THE TOWNHOMES AT BRADLEY CROSSROADS

SITE DEVELOPMENT
 PLAN
 COVER SHEET

Site Development Plan

EPC PROJ NO. PPR1846

SITE DEVELOPMENT
PLAN
ADA ROUTE PLAN

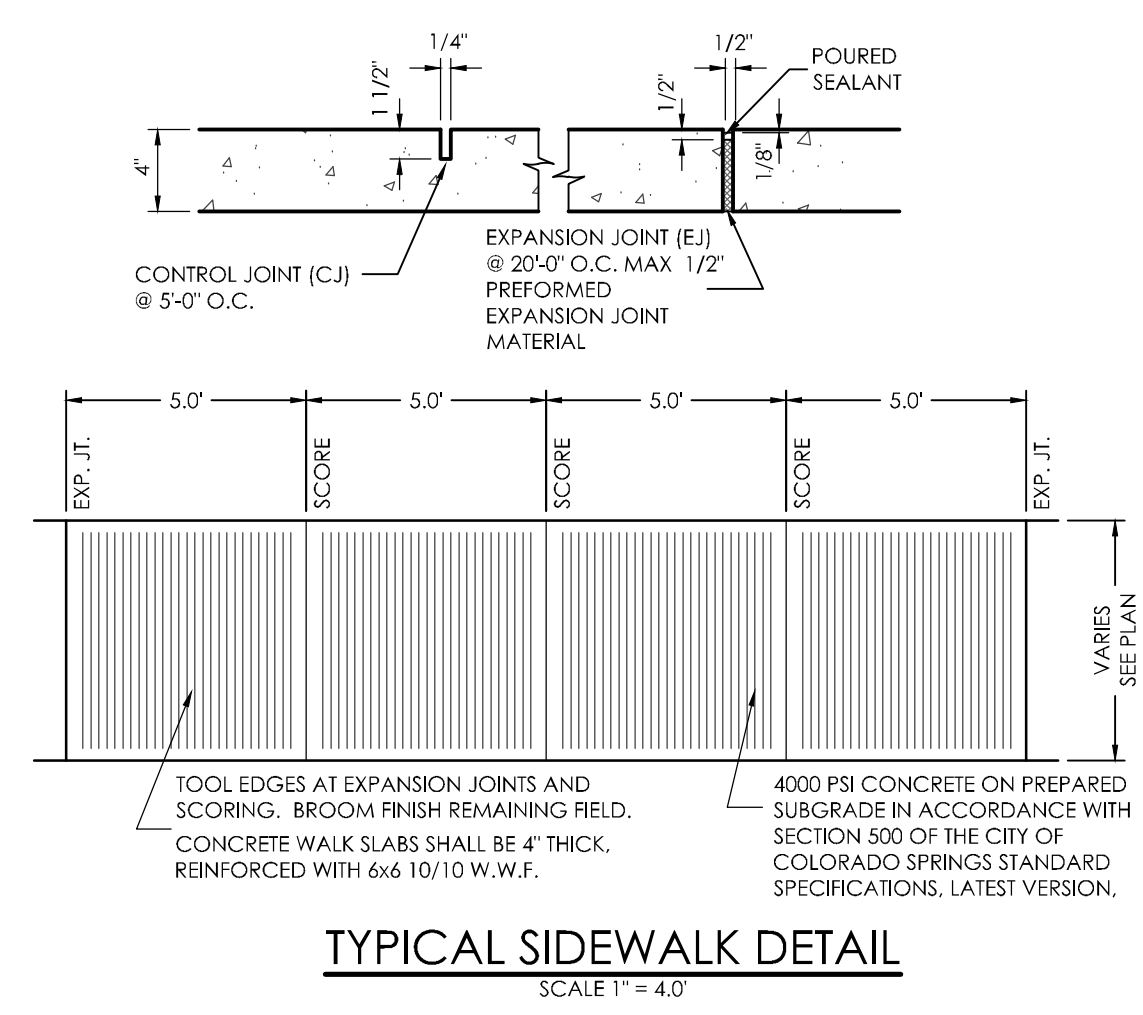
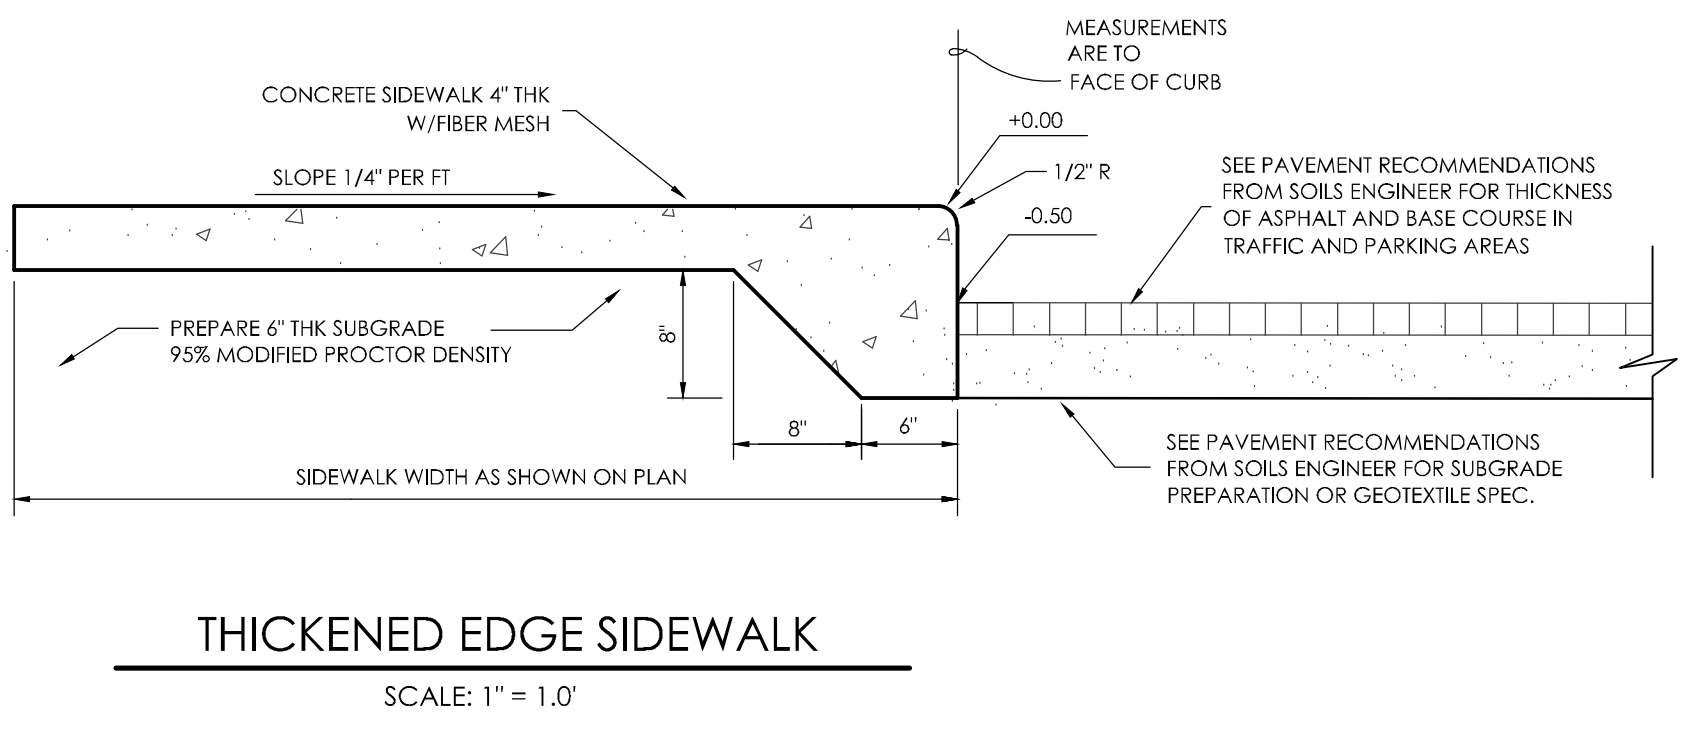
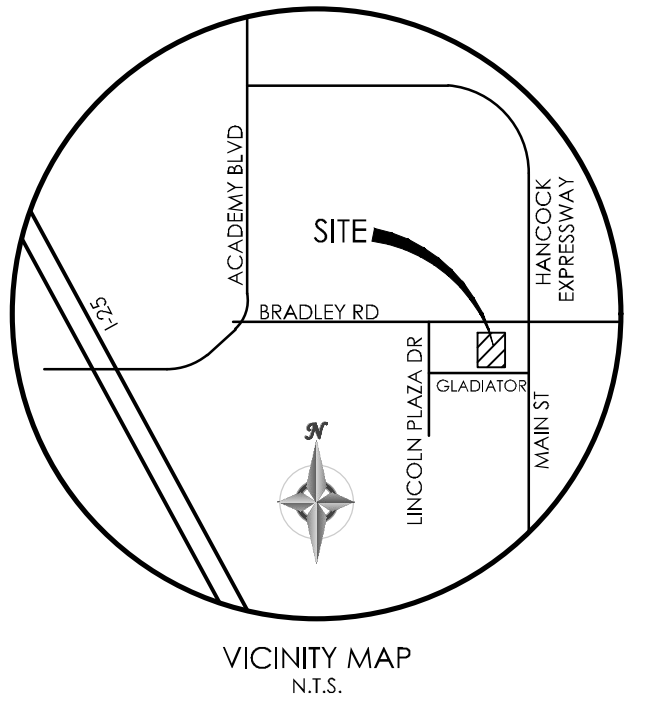
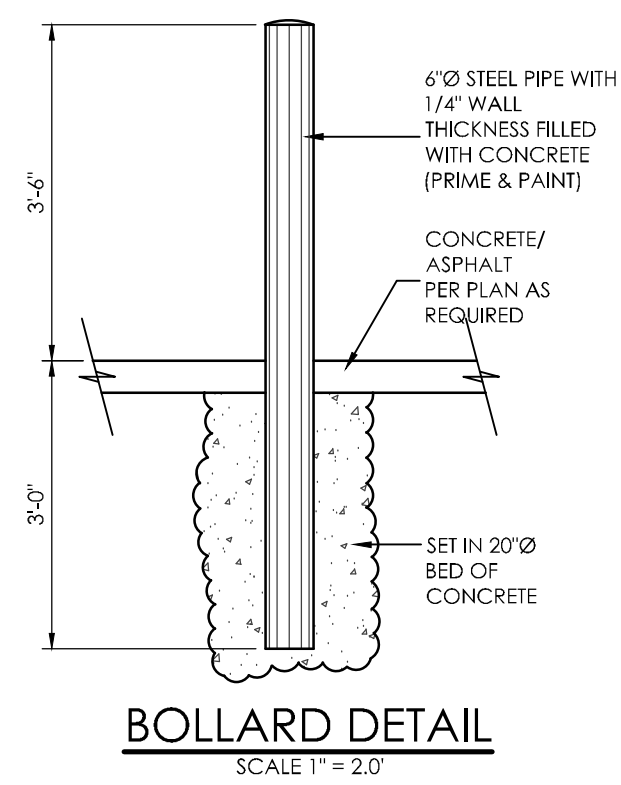
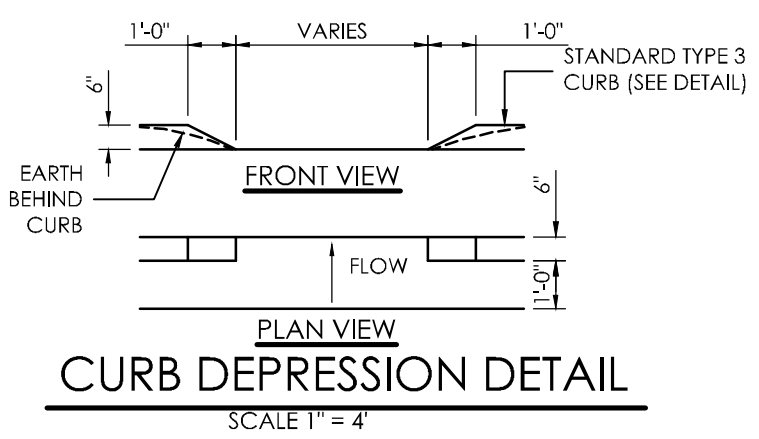
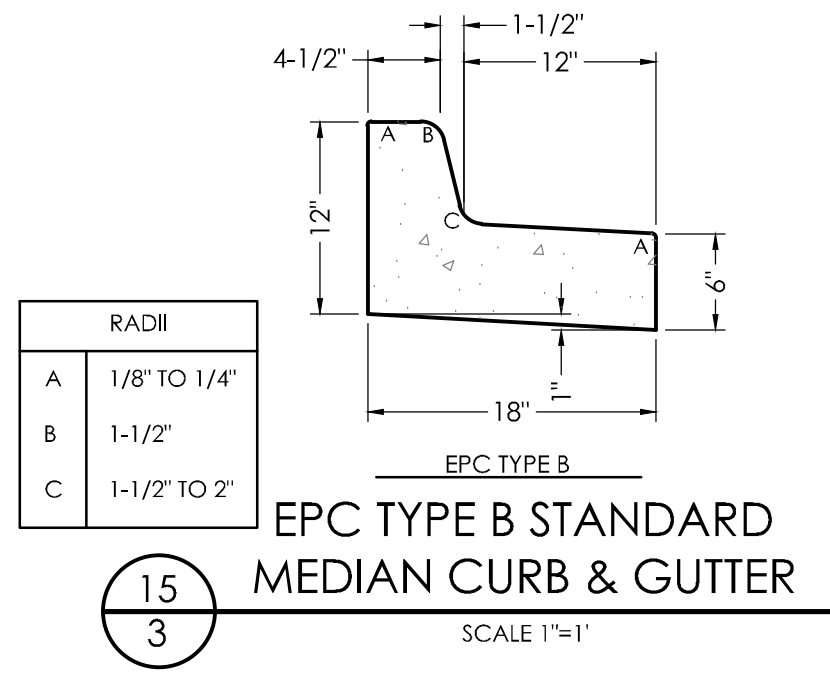
DELETE THIS- IT IS FOR CONSTRUCTION/ZONING PERMITTING APPROVAL (PRIVATE DRIVE)

THE TOWNHOMES AT
BRADLEY CROSSROADS
SITE DEVELOPMENT
PLAN
SITE DETAILS

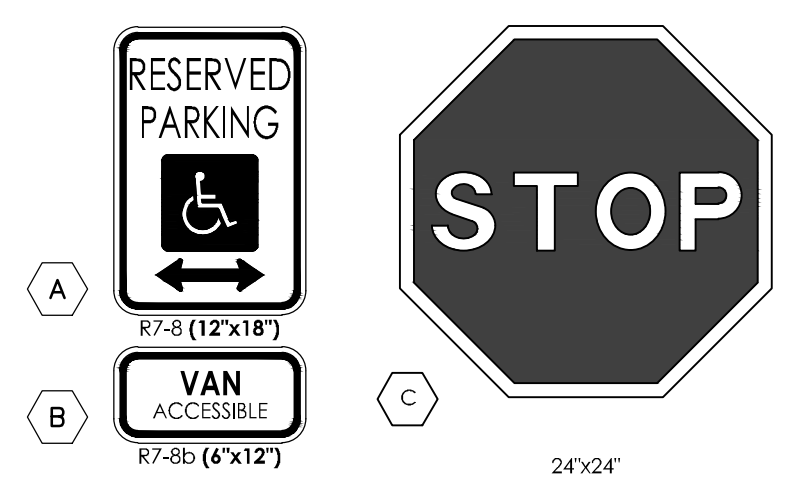
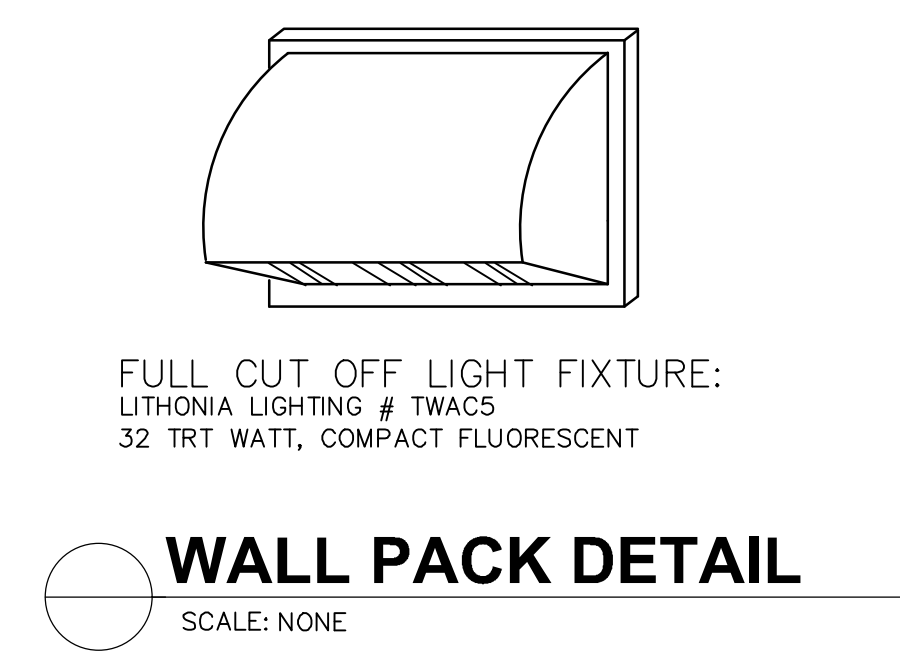
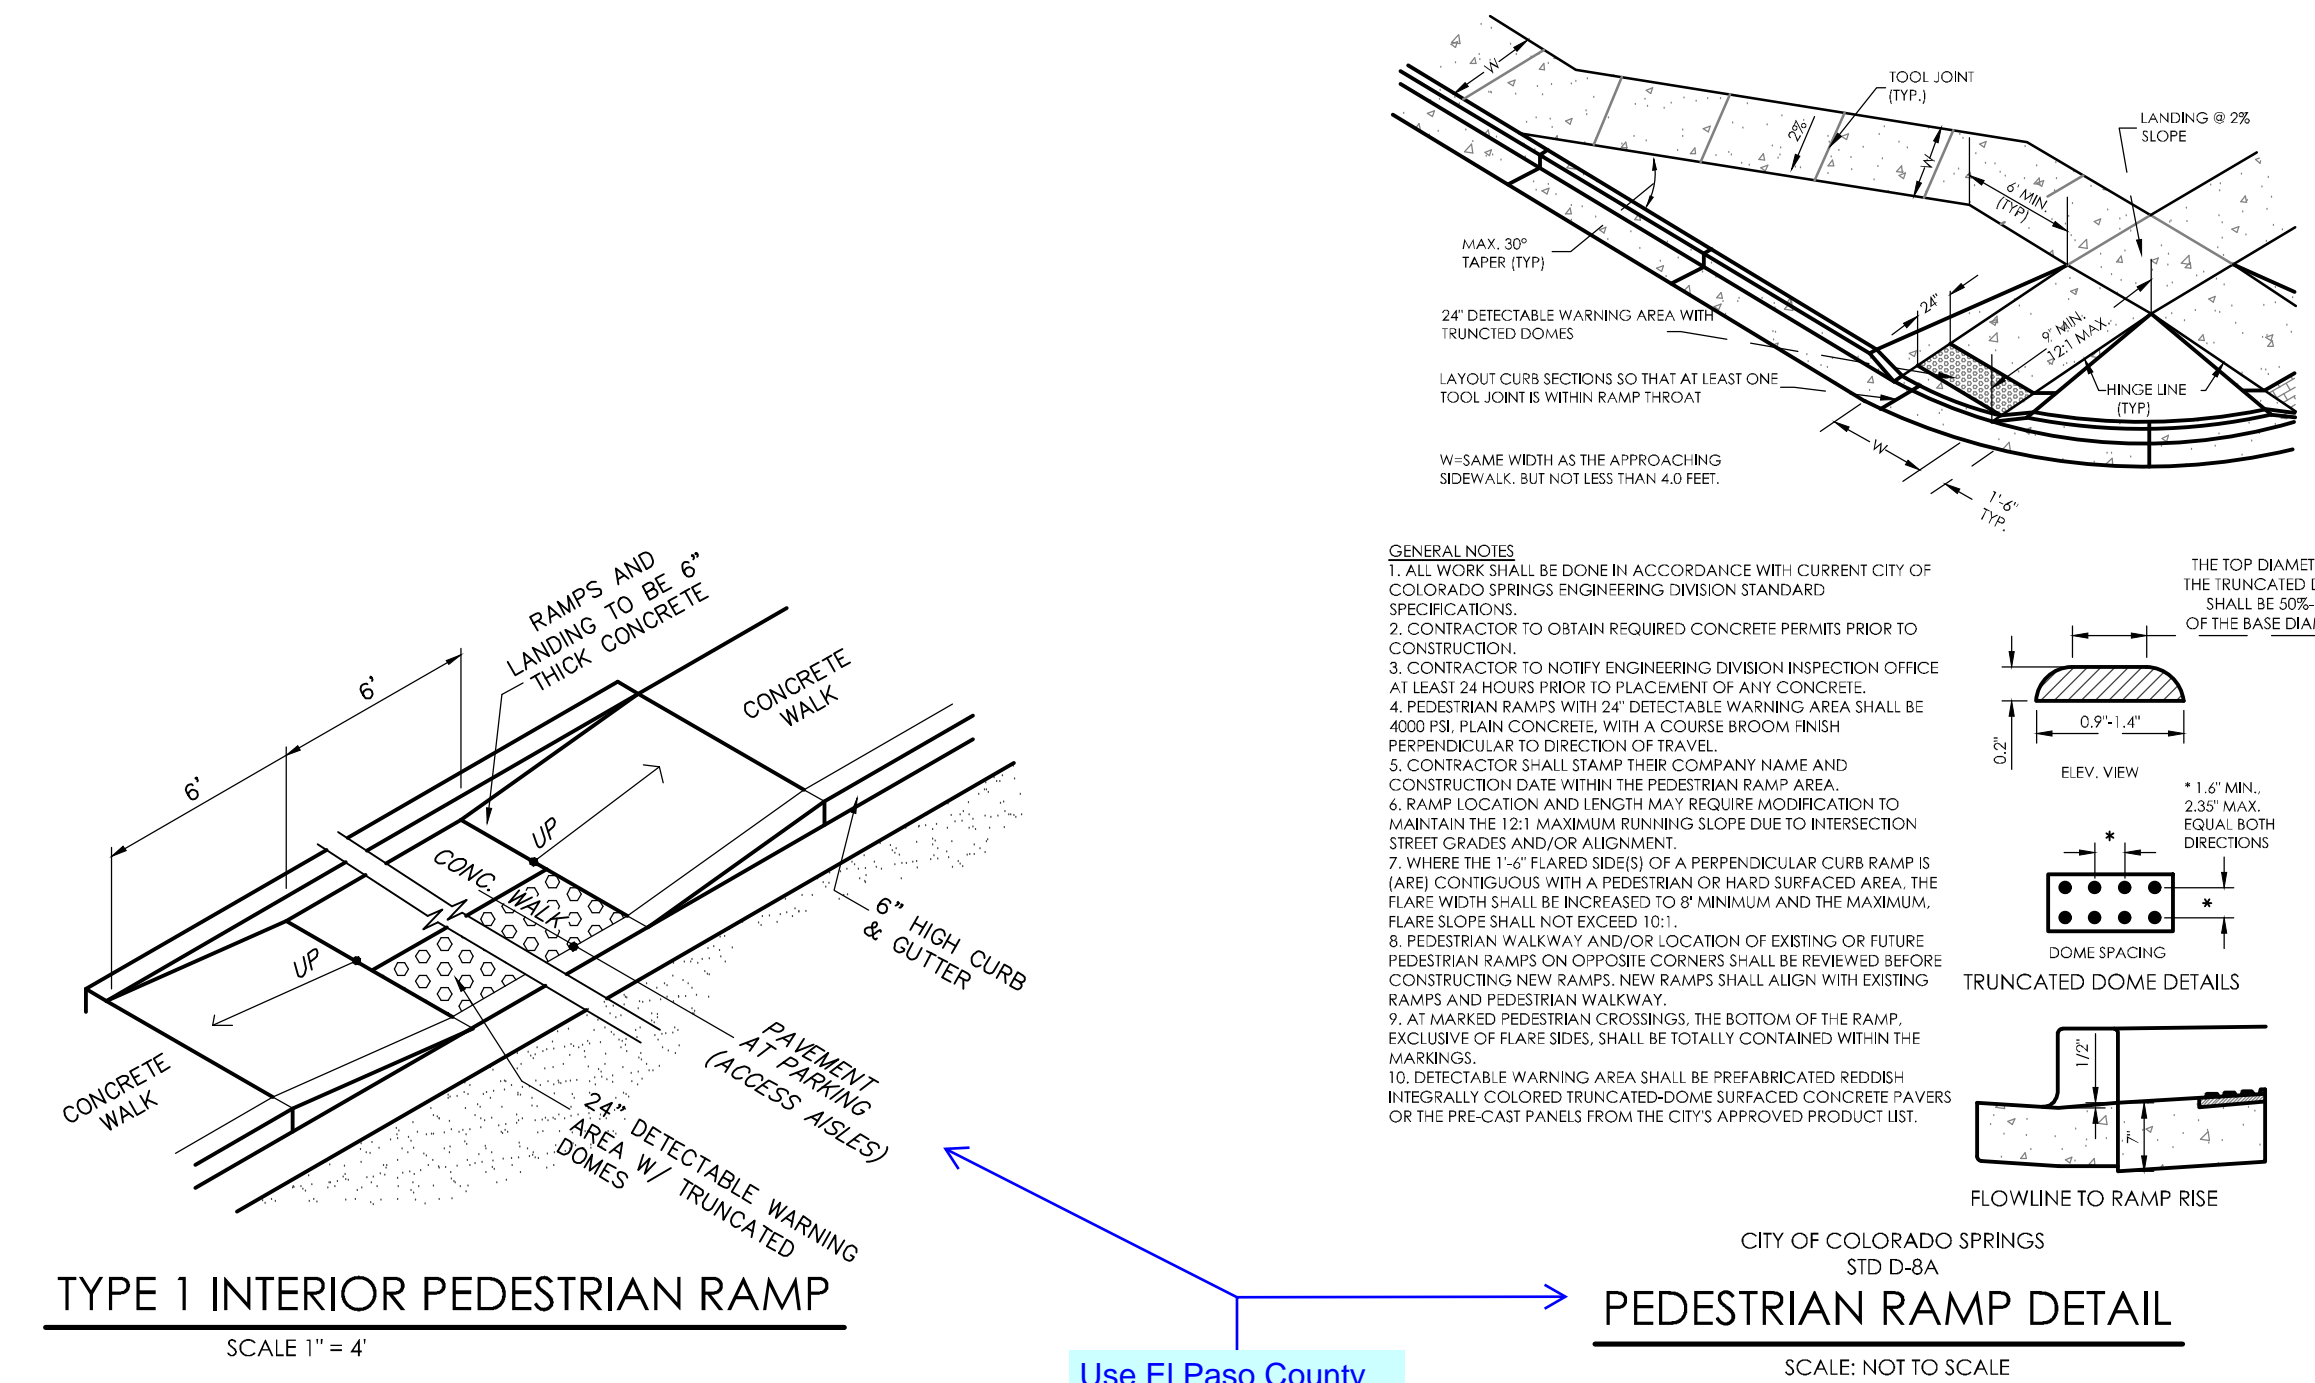
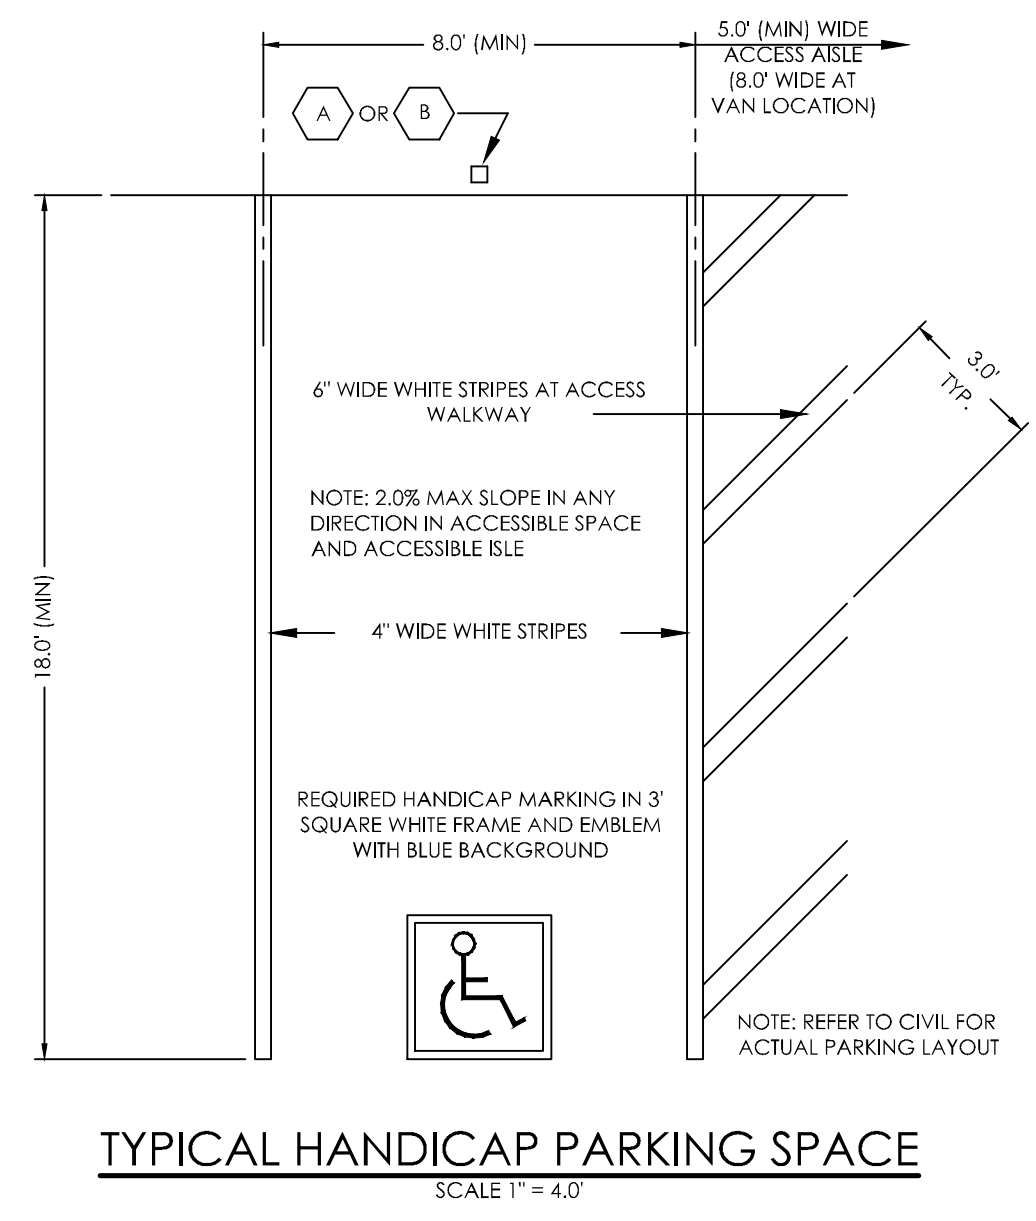
Are there street/private drive lighting? IF so provide detail and photometric plan.

trash detail?

Use El Paso County standard details
